LAND AT BILSHAM ROAD, YAPTON

Planning application ref: Y/91/17/OUT

Urban Designers Response to comments from Arun DC

12.03.18

Figure 1 : Aerial photo of the north western boundary of the site

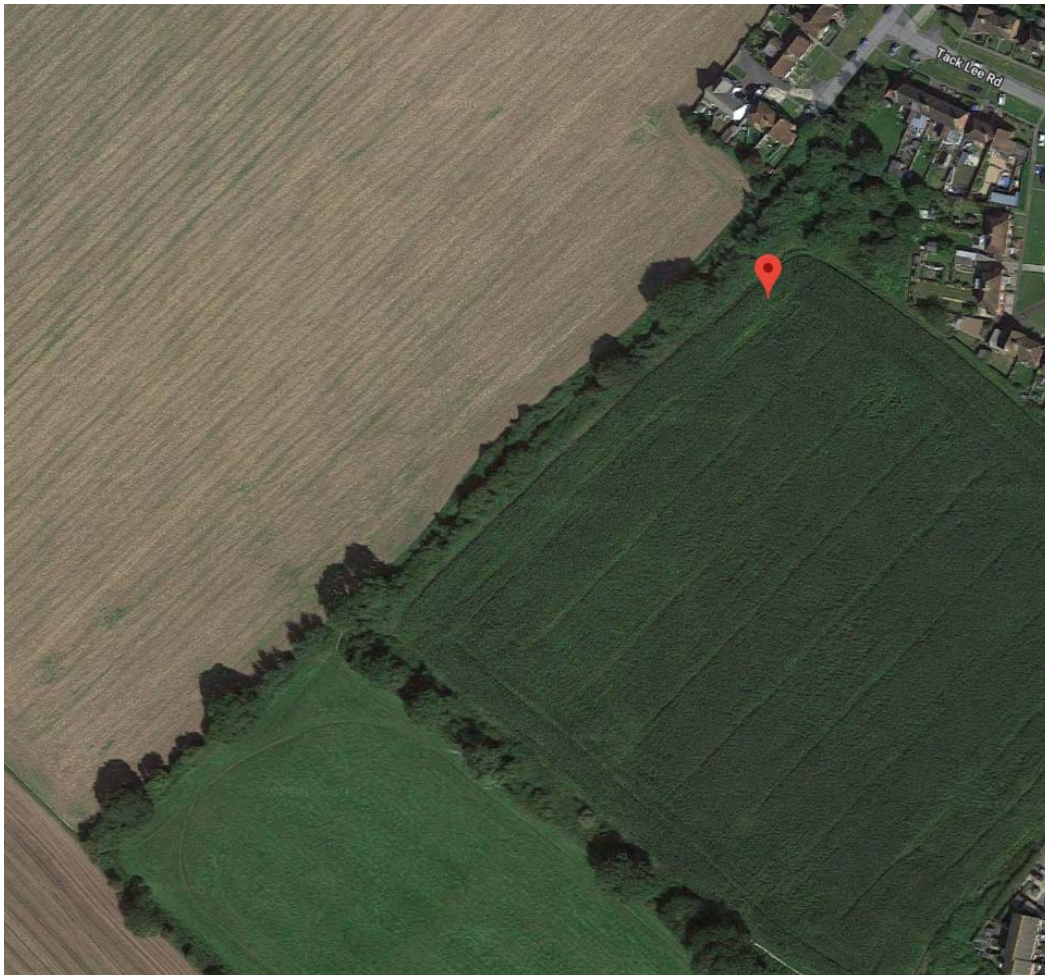
Is it possible to provide an active frontage adjacent the footpath on the north west boundary?

The existing north western boundary of the site is defined by dense vegetation with some trees (some of which are now subject to a TPO) (see Figure 1)
